MELBOURNE METRO RAIL PROJECT ENVIRONMENT EFFECTS STATEMENT
INQUIRY AND ADVISORY COMMITTEE

MMRA TECHNICAL NOTE

TECHNICAL NOTE NUMBER: 042

SUBJECT: Response to Dr John Heilig’s Request for Further Information

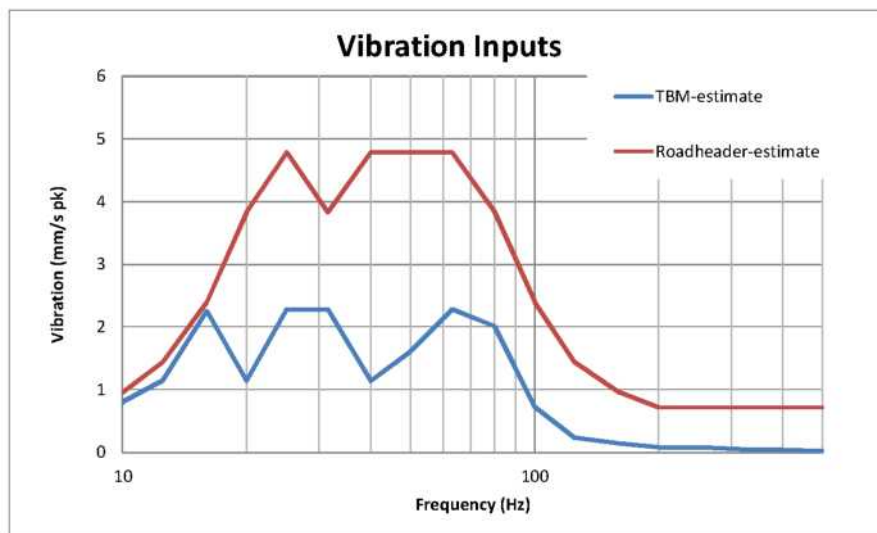
Appendix B includes Figure B.4 for the TBM and Road header vibration attenuation plots. MMRA is requested to also provide the attenuation plots with other reference vibration curves.

3. The figures below show (in red) the attenuation plots adopted in the Noise and Vibration Impact Assessment in respect of TBM and road-header excavation respectively. The figures also show other vibration estimates and test results for the purposes of comparison.

Hydromill source vibration level versus distance

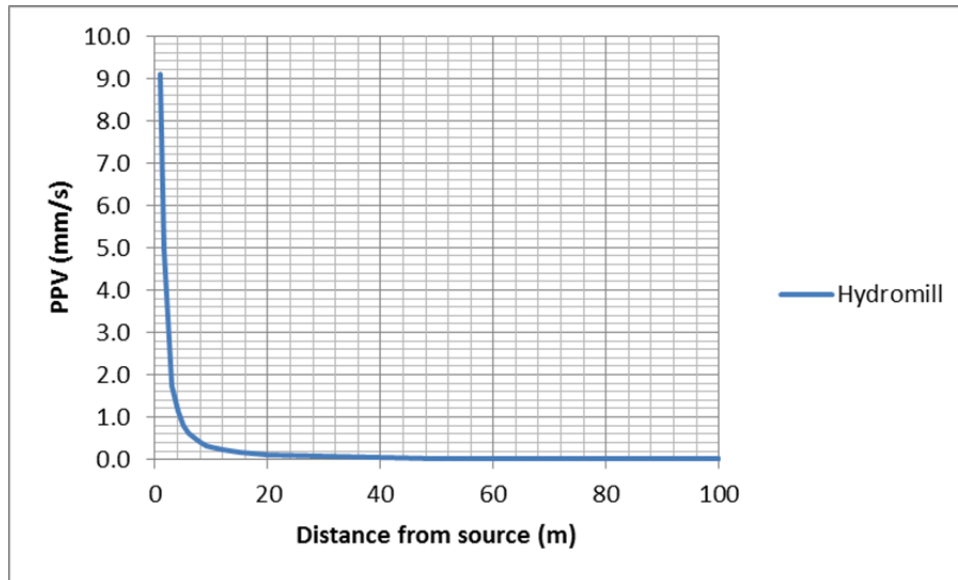
Appendix B did not provide an assessment of the cross passages. MMRA is requested to provide the results of the assessment of cross passages.

11. The equation has been modified to account for PPV in mm/s as opposed to the FTA guideline which quotes PPV in inch/s. A crest factor of 2 was assumed for the hydromill source and the operating time was assumed to be 60% of any work interval.
12. The source vibration level versus distance is given in the figure below.

14. The screening assessment for cross passage construction resulted in the identification of a 'critical' source-receiver distance of 18-19m based on ground-borne noise and human comfort vibration at night. Any source-receiver distances greater than this are predicted not to have perceptible ground-borne noise and vibration impacts due to Cross Passage Construction.

Figure 1: Maximum predicted vibration levels for receivers due to tunneling and station cavern excavation

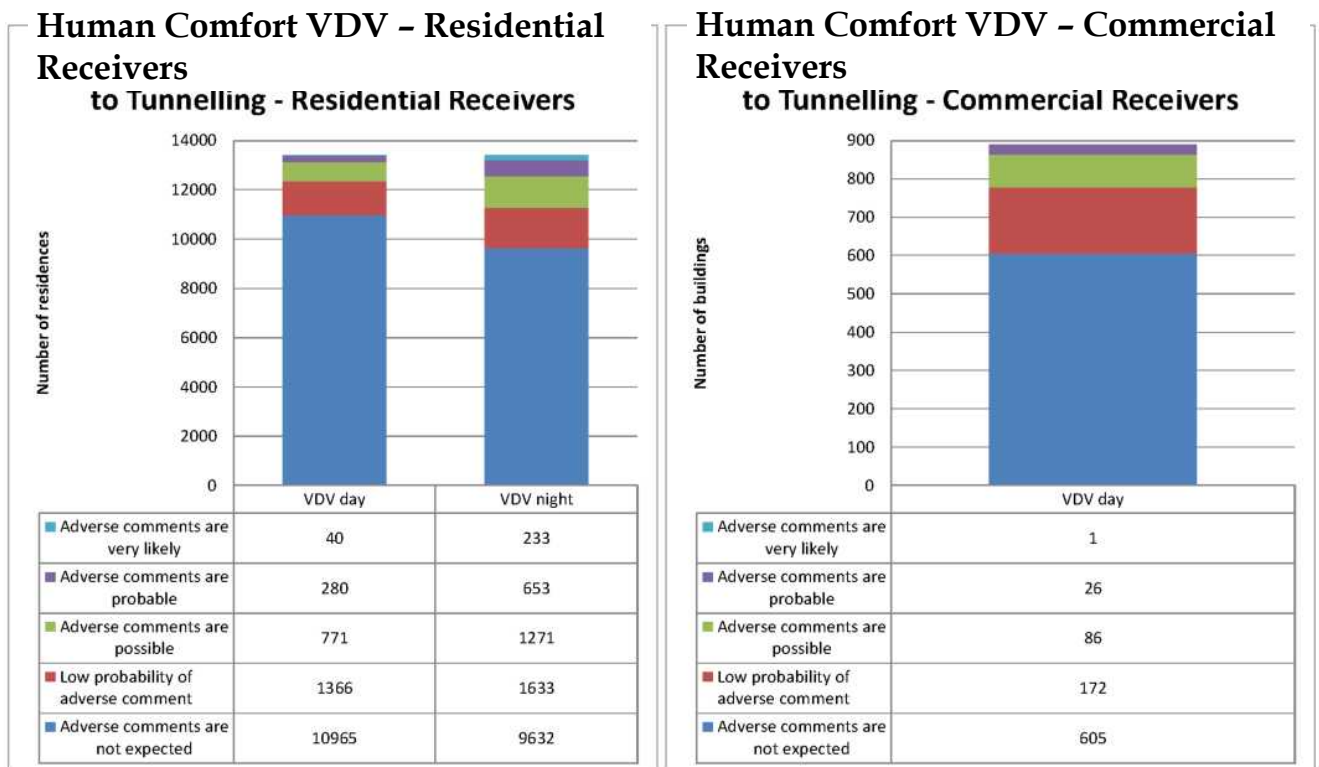
Appendix B did not provide a summary of property impacts in terms of

the number of property days affected. MMRA is requested to provide property envelopes as discussed.

22. The tables set out below summarise that information in a different format to that presented in Appendix B to the NVIA:
 - a. **Figure 1** shows maximum predicted Vibration Dose Values for receivers due to tunneling (for both TBM and road header construction) and station cavern excavation (using road headers);
